Subject: Duke Energy Carolinas, LLC
Oconee Nuclear Station
Renewed Facility Operating Licenses Numbers DPR-38, DPR-47, and DPR-55;
Docket Numbers 50-269, 50-270, and 50-287
Responses to Request for Additional Information for the License Amendment
Request to Revise Portions of the Updated Final Safety Analysis Report Related to
the Tornado Licensing Basis; License Amendment Request: 2006-009

Duke Responses to RAI

**CABLE ROUTING DIAGRAM (SCHEMATIC)
ELEVATION LOOKING EAST**

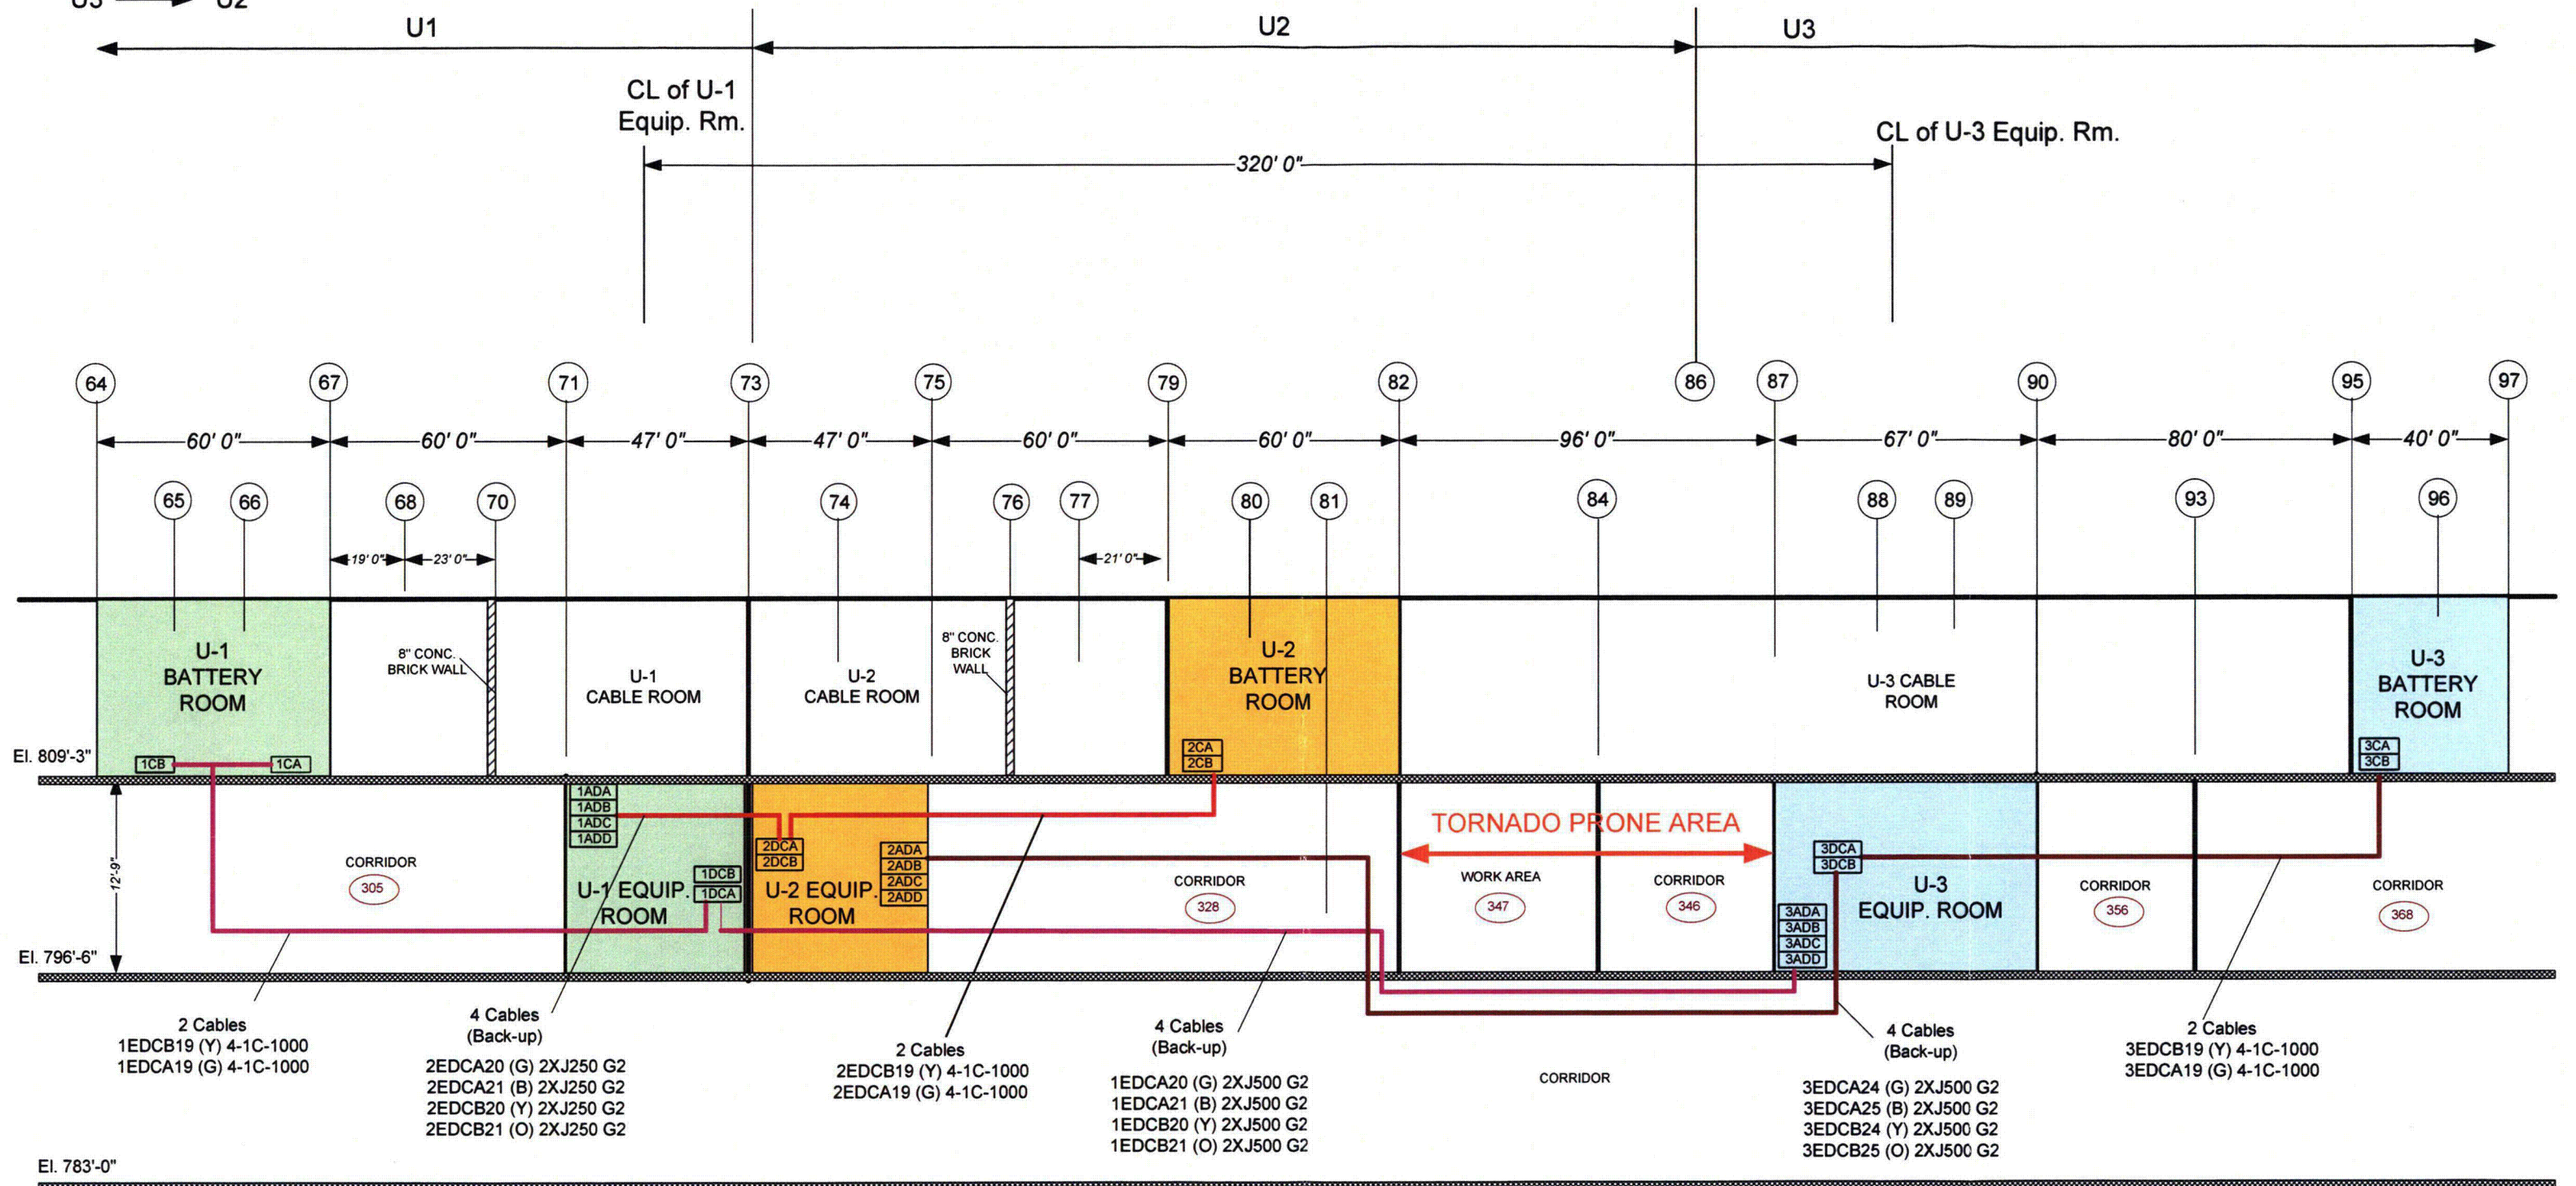
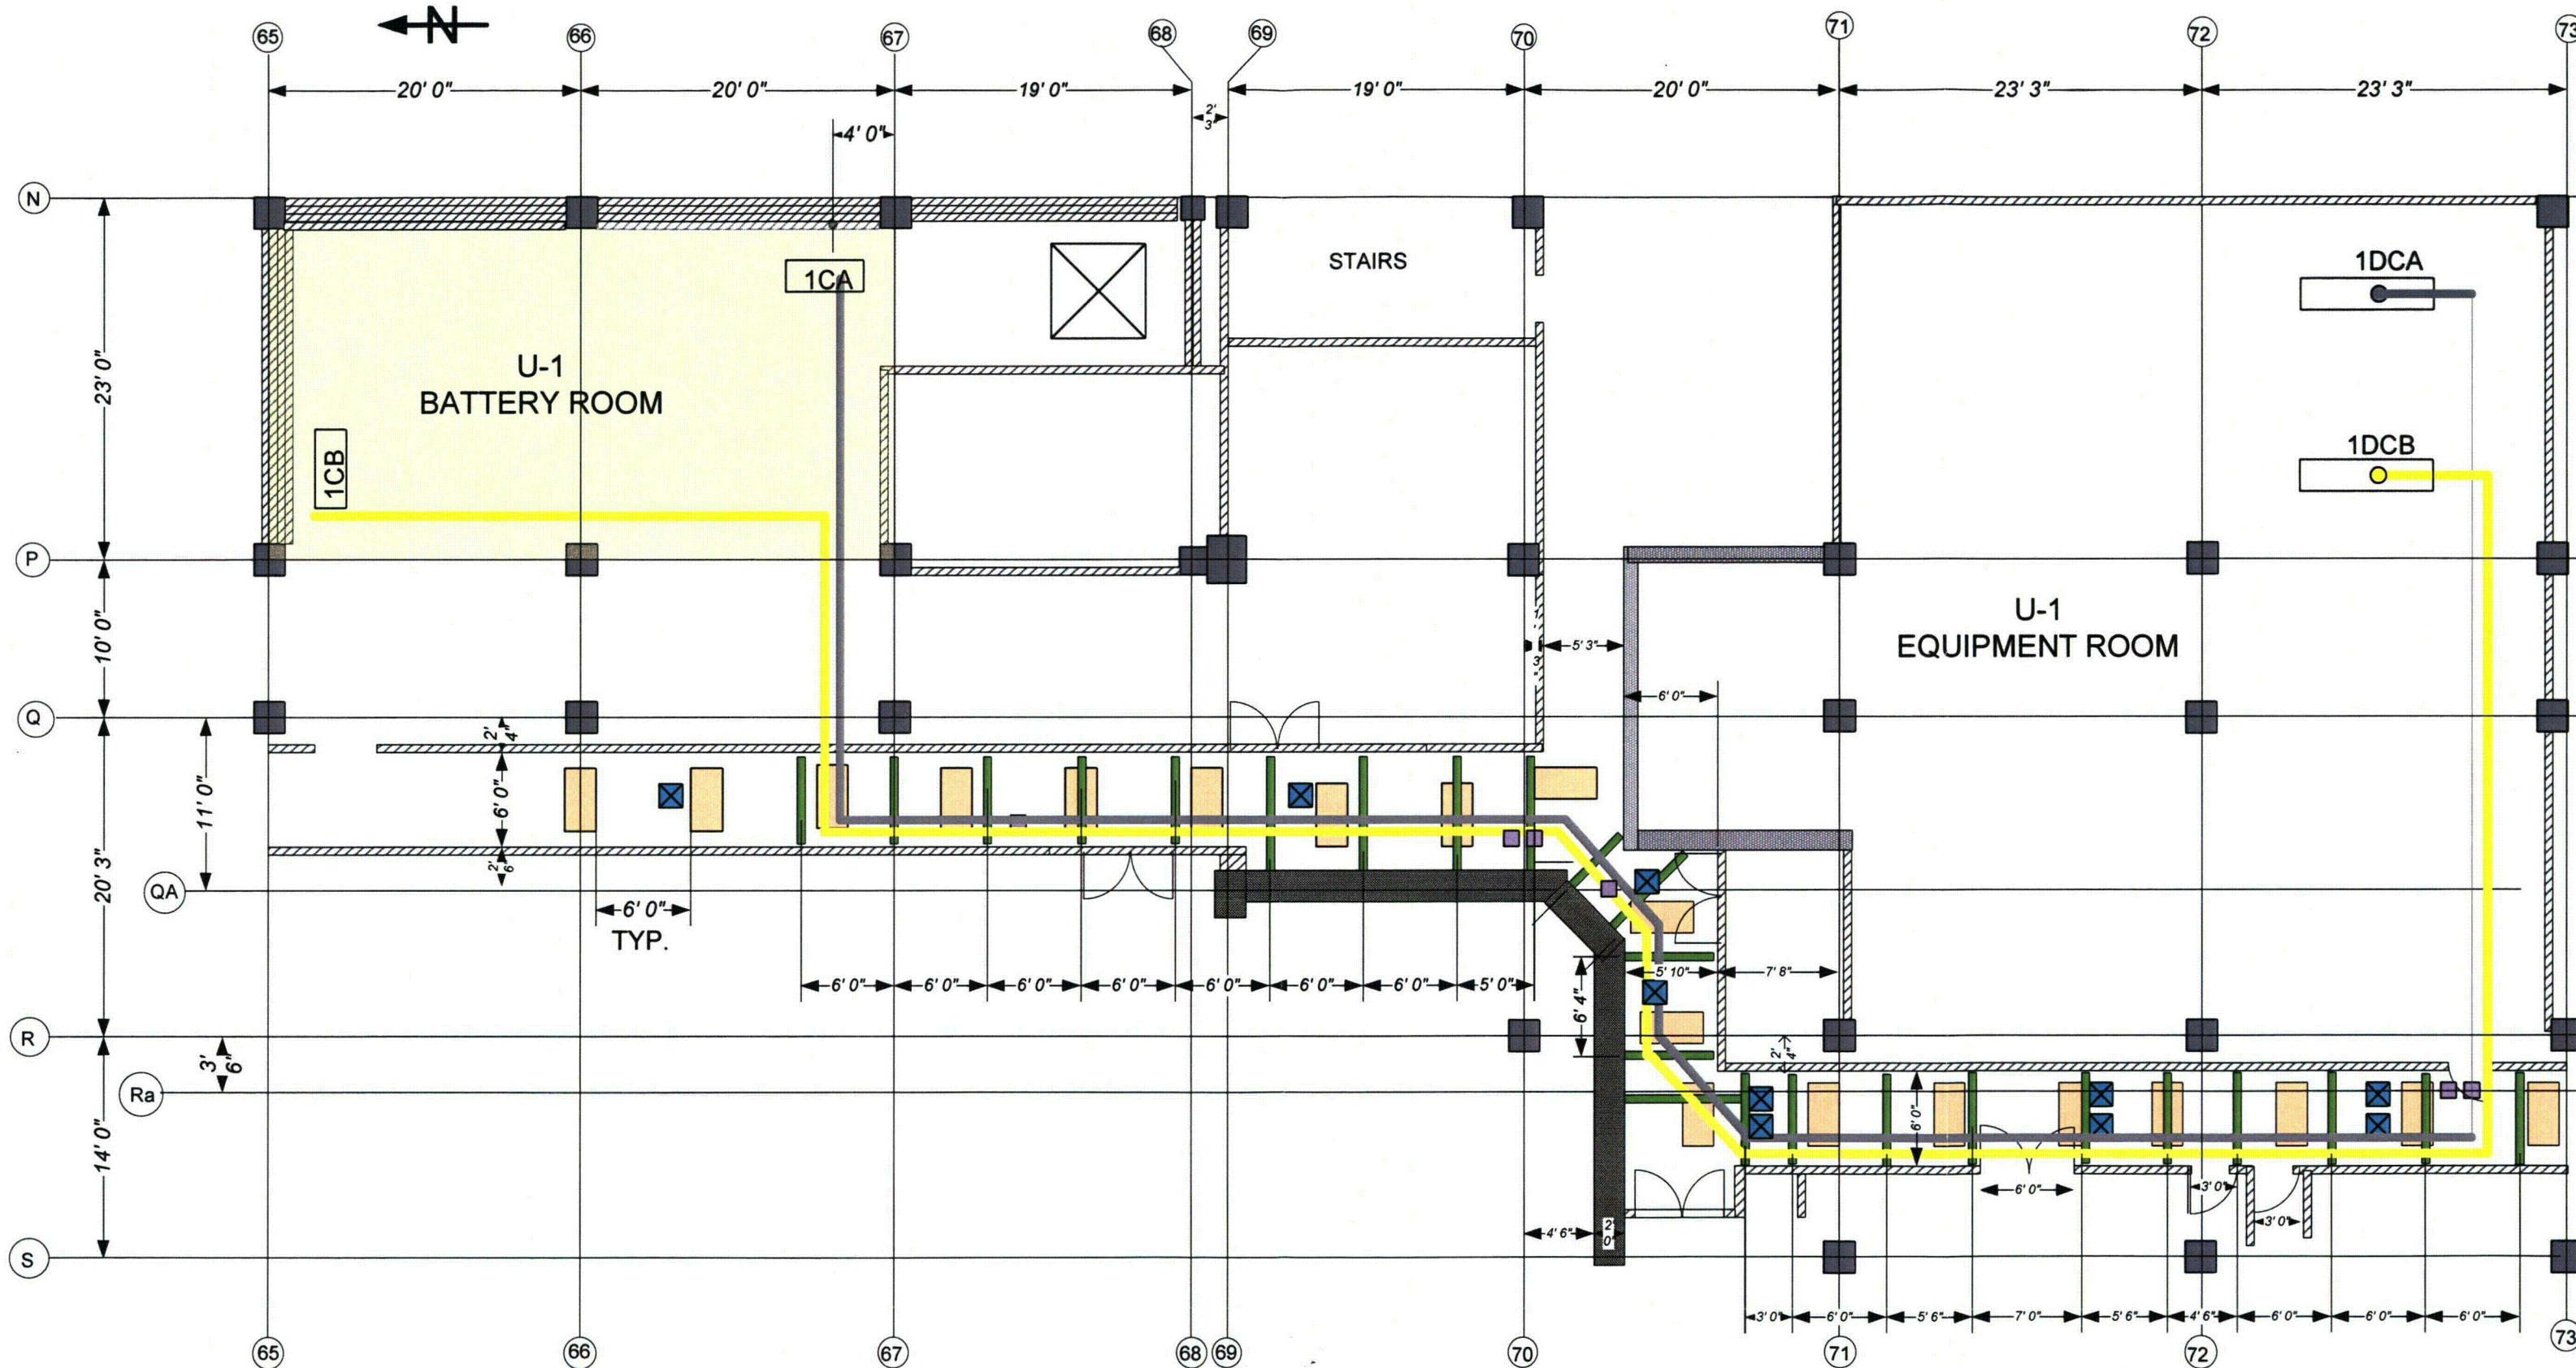
Describe in detail how the 125 VDC vital I&C primary and backup power cables and the KHU emergency start circuitry will be rerouted from the turbine building (TB) to the AB.

design basis events. The new cable routing will not affect the system functional characteristics and the termination points and each end of the cables will not change.

This design change provides new routing for the Keowee Hydro Units (KHU) emergency start cables. The existing underground spare cables between KHU and the Oconee Station will be used. For tie-in to control and logic, these underground cables will be extended with new cables between KHU termination cabinets to KHU control panels and Oconee termination cabinets to control panels in the Auxiliary Building. New emergency start cables will be installed from the 230 kV switchyard relay house via a new protected underground duct bank to the PSW switchgear building and, underground via protected duct bank, to the Auxiliary Building control panels.
